PROJECT EVALUATION: Staff has the following comments:

A PROPOSED FACILITY FOR
EL FARO CHURCH
SACRAMENTO, CALIFORNIA
REV. JOHN C. SEMCOO - PASTOR

P93-057

PLOT PLAN
SCALE: 1" = 40'

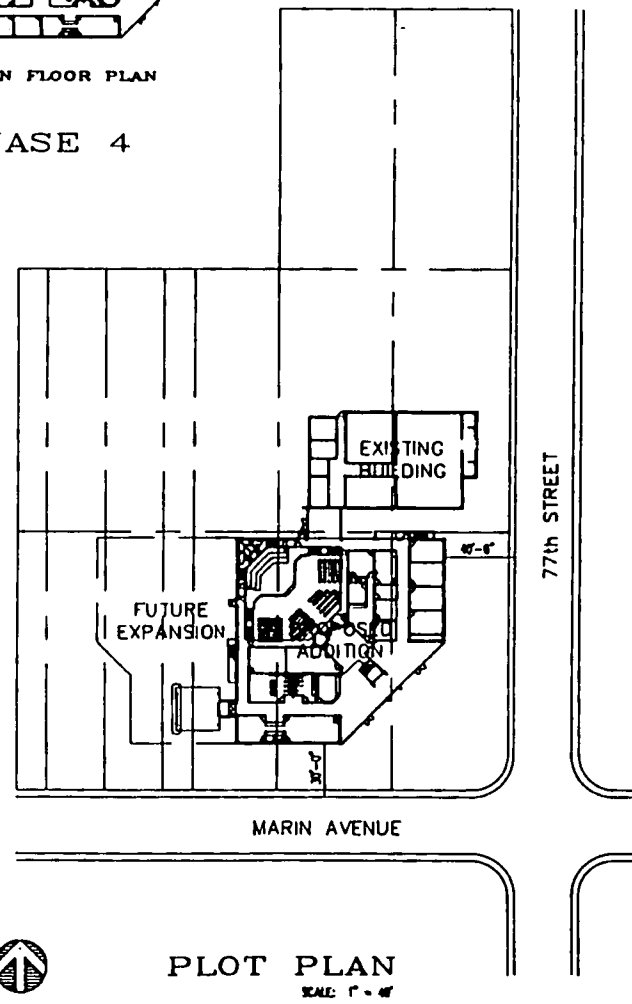
The submitted site plan indicates a new 12,950 square foot church facility to be located on the south east corner of Marin Avenue and 77th Street. Two driveway entrances are located off of Marin Avenue and four driveway entrances are off of 77th Street. Currently a cyclone fence is provided along a portion of the northeast property line and a wrought iron fence is located on the remaining portion of the property line facing the church. The site plan indicates the existing dwelling to be demolished. A demolition permit will be required prior to tearing down the dwelling. It is recommended that a six foot high wrought iron fence be provided along the remaining portion of the eastern property line facing the new church facility and along Marin Avenue (Exhibit B). A six foot high concrete wall is located along the north and west property lines. The new church facility will be setback approximately 40 feet from 77th Street and 30

feet from Marin Avenue. Sufficient setbacks are provided.

No trash enclosures or signage is indicated on the submitted site plan. Staff recommends that a trash enclosure be provided on the site and built to the standards in the Zoning Ordinance. The enclosures should also provide adequate receptacles for recycling in accordance with the recycling requirements of the Zoning Ordinance. Any signage must meet all the requirements required by the Sign Ordinance and have a sign permit. A landscape plan has not been submitted for staff's review. It is recommended that a landscape and irrigation plan be submitted for Planning staff's review and approval prior to issuance of building permits. All new designated parking areas shall meet the 50 percent shading requirement.

As previously noted, there are two driveway entrances/exits off of Marin Avenue and four off of 77th Avenue. The layout of the parking lot indicates a total of two-hundred parking spaces to be provided for total build-out. There are currently 80 parking spaces on the site and a total of 81 spaces are required for 325 seats based on the Zoning Ordinance requirement of one space for every four seats. Staff recommends the addition of one more space to fulfill the parking requirements.

Staff has concern with the entire 200 parking spaces being provided in the first phase. With the existing number of parking spaces plus one space meeting the requirement for a 325 seat church facility (81) spaces, there is no need to provide additional parking spaces for the remaining phases which may not occur. The applicant indicated to staff that the future build-out solely depends on economics and demand. Therefore, there is no guarantee that this parking additional parking will be needed. In addition, the City's Traffic Engineer has indicated to staff that the proposed design is unacceptable and the driveway ingress and egress shall be limited to two on site. Staff, therefore, recommends that the proposed lot be revised to the satisfaction of the City's Traffic Engineer prior to issuance of any building permits. The vacant north east lot fronting on 77th Street, designated for 56 future parking, shall not be paved nor used for parking vehicles. Minimum 7 foot wide planters shall be provided along Marin Avenue where new parking will be located. Future development on the site requiring additional parking will be subject to a Special Permit and review and approval by the City's Traffic Engineer.

4. A demolition permit shall be obtained prior to tearing down the residential dwelling.
5. A six foot high wrought iron fence shall be provided along the remaining portion of the eastern property line facing the new church facility and along Marin Avenue (Exhibit B).

9. The driveway ingress and egress shall be limited to two on site.
10. A proposed parking lot shall be revised to the satisfaction of the City's Traffic Engineer prior to issuance of building permits. The existing parking lot shall be increased by one space prior to the granting of the Certificate of Occupancy.

11. The vacant north east lot fronting on 77th Street, designated for 56 parking spaces shall not be paved nor used for parking vehicles and shall be barricaded.

12. Minimum seven foot wide planters shall be provided along Marin Avenue where new parking will be located.
13. The church bell tower shall not be rung prior to 8:00 A.M. and after 10:00 P.M.

MAIN FLOOR PLAN

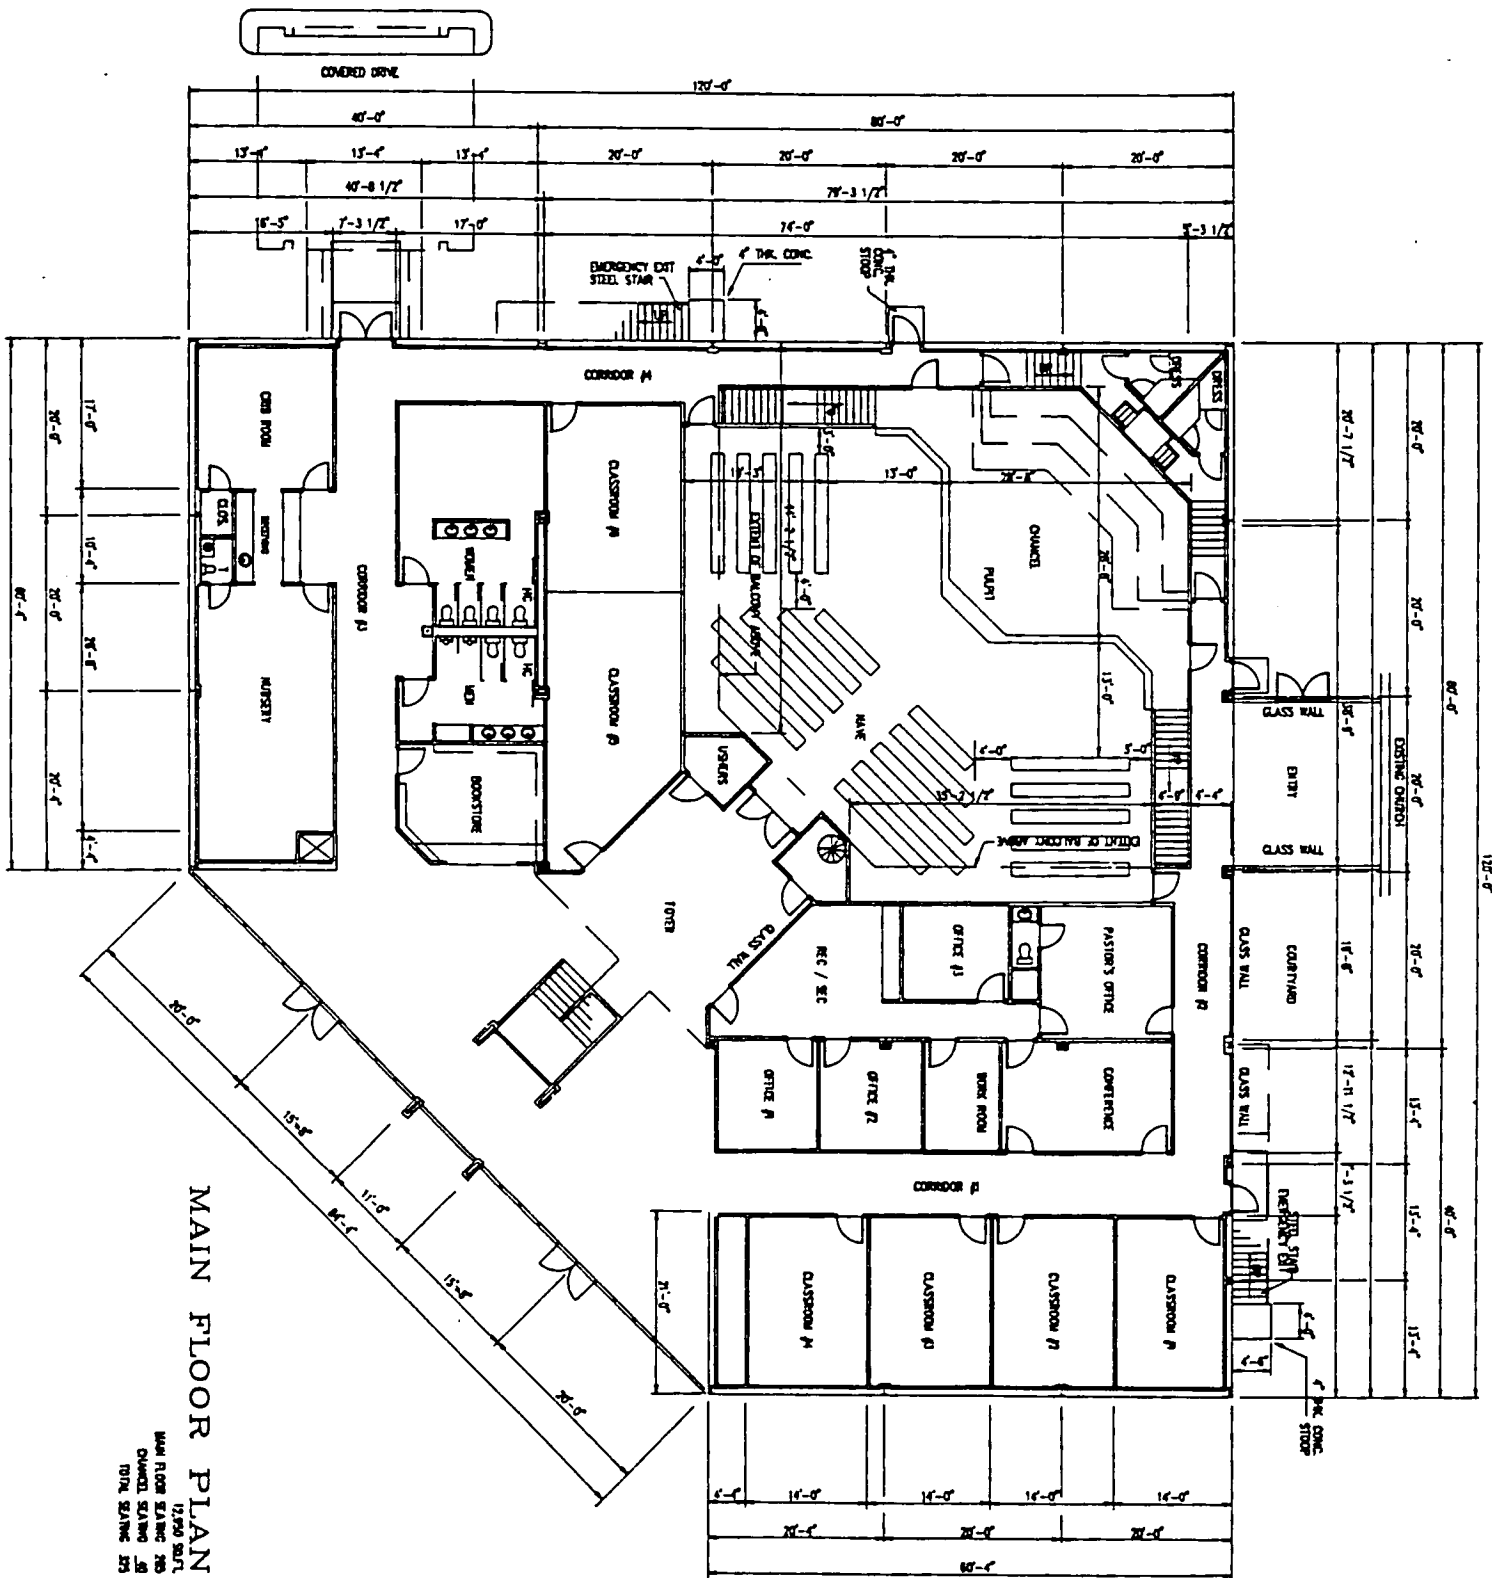
The floor plans indicate 14 classrooms, nursery, bookstore and conference room in addition to four offices. In addition, the floor plan indicates a walkway to be provided between the existing church and the new church. The proposed walkway will be a lobby enclosed by a glass wall. The proposed building design was reviewed by the City's Design Review Coordinator.

EXTERIOR ELEVATIONS
A PROPOSED FACILITY FOR
EL FARO CHURCH
SACRAMENTO, CALIFORNIA
REV. JOHN C. SERENIO - PASTOR

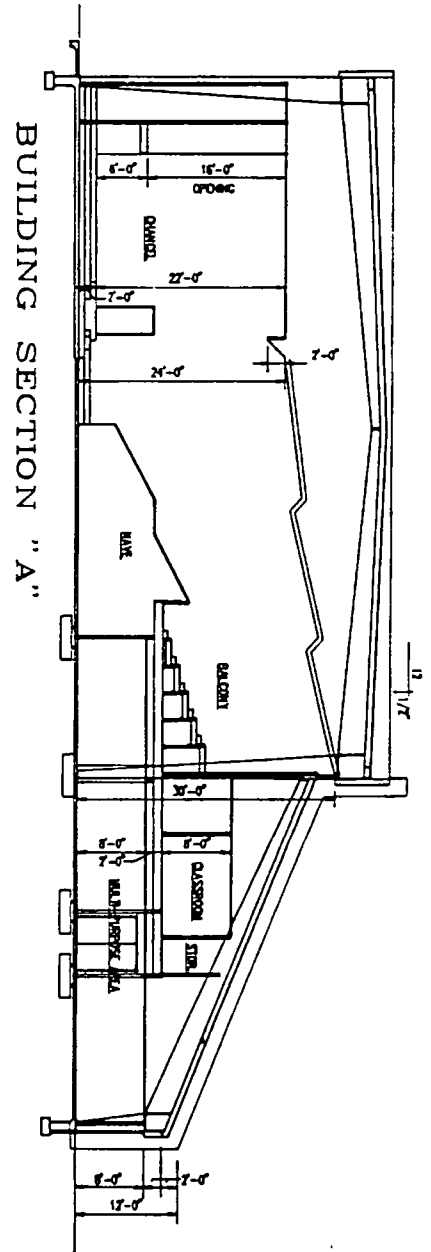
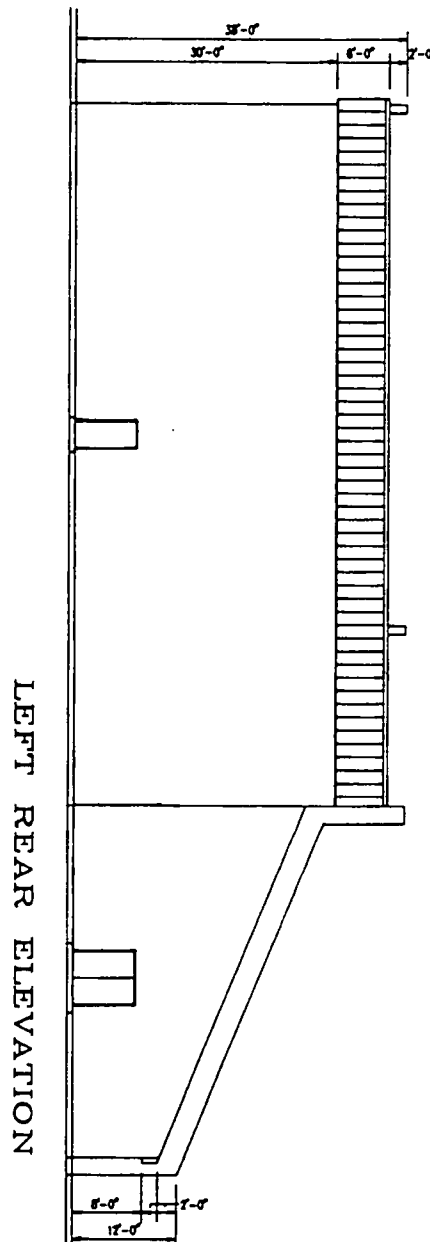
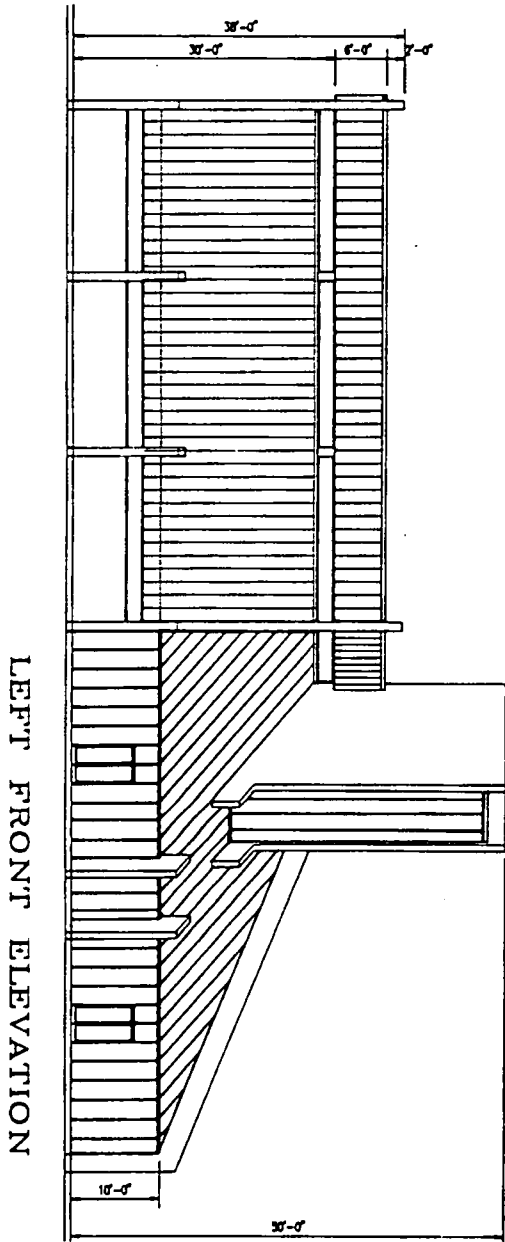
The applicant submitted floor plans and elevations for the proposed new church addition. Exterior building materials consist of stucco with a light tan building color. Roof material will be standing seam. The elevations indicate a 30 foot high structure with a 50 foot high bell tower. The proposed building materials will be compatible with the surrounding residential neighborhood and existing church facility.

A variance is requested to exceed the required 35 foot height limit in the (R-1) zone. The proposed bell tower will be 50 feet in height. The bell tower will be incorporated into the church and will extend approximately 14 feet above the roof line totaling 50 feet from grade level to the highest point. The proposed bell tower's material and color is compatible with the existing church.

Staff had some concerns with the time of day the bell tower will be rung, since the use is surrounded by residential on all four sides. Staff, therefore, recommends that the church bell tower not be rung prior to 8:00 A.M. and after 10:00 P.M. Since the proposed 50 foot high bell tower will be an architectural feature and will be compatible with the existing structure and will not be a distraction in the neighborhood, staff supports the variance to exceed the 35 foot height limit.
